No. EL/4.2.15

**MODIFICATION SHEET NO. RDSO/2012/EL/MS/ 0410 Rev '0'**  
**Dated: 04.06.2012**

Circuit modification of I-68 branch for C145 operation feedback for 25 kv ac electric locomotives fitted with MPCS.

| RDSO. ELECT. DTE.  |                  |             |                 | SKEL-4880                   | SUPERSEDED BY |       |

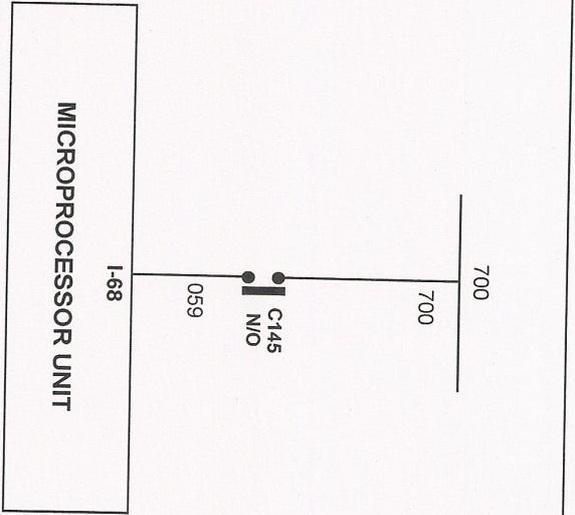
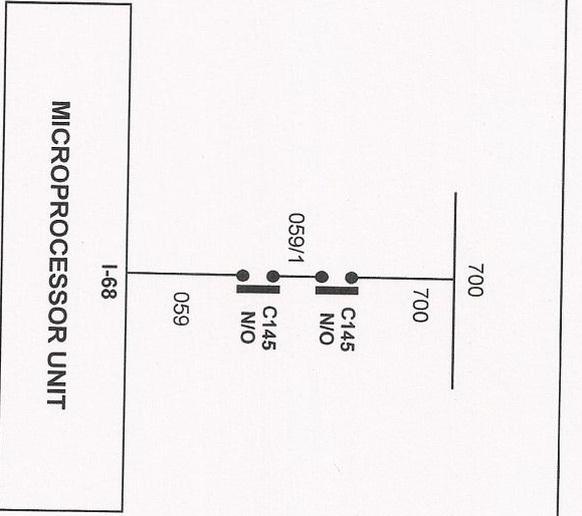
Recently some cases of "C145 contact stuck up and total loss of traction" have resulted failure of locomotive on line. Due to defect in C145 N/O auxiliary contact, input I-68 for MPCS became high while MPCS output O-15 was low.

This problem occurs when loco pilot uses dynamic braking in loco and switch over from braking mode to traction mode and power contact does not open OR due to malfunctioning of auxiliary contact of C145. In these cases LSB does not extinguish in Traction mode resulting notch not progressing.

To avoid failure of locomotive on line due to malfunctioning of auxiliary contact, it is advised that two N/O auxiliary contact of C145 in series should be used (as used in braking side conventional loco) for I-68 input branch. As such closing of C145 will be ascertained by two auxiliary contacts and malfunctioning of one auxiliary contact will not cause TLTE.

- Two N/O auxiliary contact of C145 will be connected in series in I-68 branch as shown in enclosed drawing SKEL – 4880. Existing circuit as well as Modified circuit for I-68 input have been shown.

Existing Circuit

Modified Circuit

One spare N/O auxiliary contact of C145 should be connected in series with the existing N/O auxiliary contact by Railways.

Two N/O auxiliary contact of C145 of extreme outside will be used.
